**Subject:** **<u>UPDATE</u> - Special Service Campaign (SSC) 7LB (Safety Recall) Lexus ES 350 All Weather Floor Mat Accessory for 2007 and Early 2008 Model Year Vehicles**

**Special Service Campaign (SSC) – 7LB (Safety Recall) Q&A**

**SSC 7LB – LEXUS ES 350 ALL WEATHER FLOOR MAT ACCESSORY**
**FOR 2007 AND EARLY 2008 MODEL YEAR VEHICLES**
**SAFETY RECALL NOTICE**

**Lexus ES 350 All Weather Floor Mat Involved in this recall**

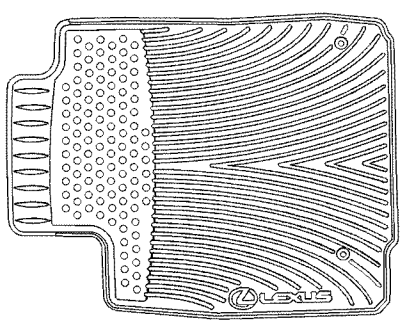
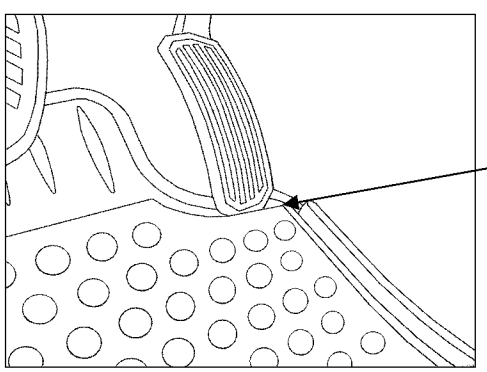
The optional Lexus ES 350 All Weather Floor Mat includes two grommet holes in the All Weather Floor Mat and retaining hooks (clips) to secure the mat to the vehicle's carpet. Lexus has received reports that if the optional Lexus ES 350 All Weather Floor Mat (either by itself or if it is placed on top of an existing carpeted floor mat) is not secured by the retaining hooks (clips), the mat can move forward and interfere with the accelerator pedal returning to the idle position. ***If the mat is properly secured, it will not interfere with the accelerator pedal.***

If the Lexus ES 350 All Weather Floor Mat is not **secured by the retaining hooks (clips)** and the mat moves forward, it may interfere with the accelerator pedal.

**Lexus ES 350 All Weather Floor Mat**
**Involved in this recall**

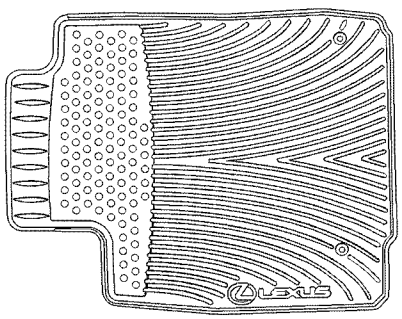
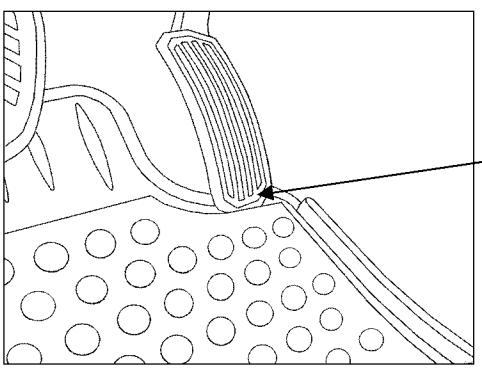
The *optional* Lexus ES 350 All Weather Floor Mat is specifically engineered and manufactured for ES 350 vehicles. There are two grommet holes in the All Weather Floor Mat and retaining hooks (clips) attached to the carpet of the vehicle to secure the mat. Lexus has received reports that if the optional Lexus ES 350 All Weather Floor Mat (either by itself or if it is placed on top of an existing carpeted floor mat) is not secured by the retaining hooks (clips), the mat can move forward and interfere with the accelerator pedal returning to the idle position. If this condition occurs, in the worst case, it may increase the possibility of a crash.

If the Lexus ES 350 All Weather Floor Mat is not **secured by the retaining hooks (clips)** and the mat moves forward, it may interfere with the accelerator pedal.

Any Lexus dealer will replace the original driver's seating position All Weather Floor Mat with a newly designed one at **NO CHARGE** to you.
